Access Compliance Report

Public Rights-of-Way

Intersection ID: 14794	Main Street: BUCHANAN_ST	Cross Street: DILWORTH_RD_EAST	Location: NE
ADA ID: B5980B68E7FD	Ramp Type: Perp	Initial Pass/Fail: Fail	Overall Compliance: No
Severity Score: 12.5			
Codes/Mitigation Info/Possible Solution		Field Measurements/Component Compliance

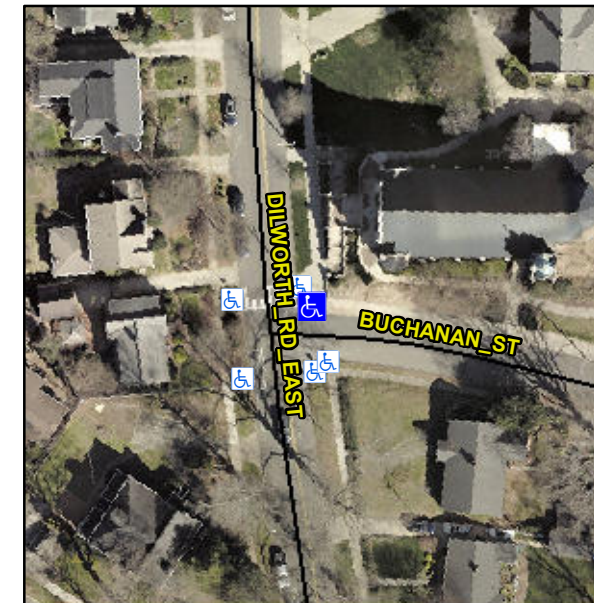
R304.5.3

Compliance	Description	Data	Compliance	Description	Data
N/A	Ramp Length (in)	51.0	Yes	Ramp Slope (%)	5.1
Yes	Ramp Width (in)	84.0	No	Ramp XSlope (%)	5.3
N/A	Flare Type LT	N/A	N/A	Flare Type RT	N/A
N/A	Flare Slope LT (%)	N/A	N/A	Flare Slope RT (%)	N/A
N/A	Flare Traversable LT?	N/A	N/A	Flare Traversable RT?	N/A
N/A	Landing Length (in)	N/A	N/A	DWS Provided?	N/A
N/A	Landing Width (in)	N/A	N/A	DWS Contrast?	N/A
N/A	Landing Slope (%)	N/A	N/A	DWS Length (in)	N/A
N/A	Landing X Slope (%)	N/A	N/A	DWS Full Width?	N/A
N/A	Landing Curb? (Y/N)	N/A	N/A	DWS Offset (in)	N/A
N/A	Shared Landing?	N/A			
N/A	Gutter Ponding?	N/A	N/A	Gutter Slope (%)	N/A
N/A	Gutter Lip Ht (in)	N/A	N/A	Gutter X Slope (%)	N/A
N/A	Painted X Walk1?	No	N/A	Painted X Walk2?	N/A
	X Walk 1 Direction	To S		X Walk 2 Direction	N/A
N/A	X Walk 1 Width (in)	N/A	N/A	X Walk 2 Width (in)	N/A
	X Walk 1 Slope (%)	6.2		X Walk 2 Slope (%)	N/A
	X Walk 1 X Slope (%)	3.7		X Walk 2 X Slope (%)	N/A

Remove & Replace Entire Ramp.
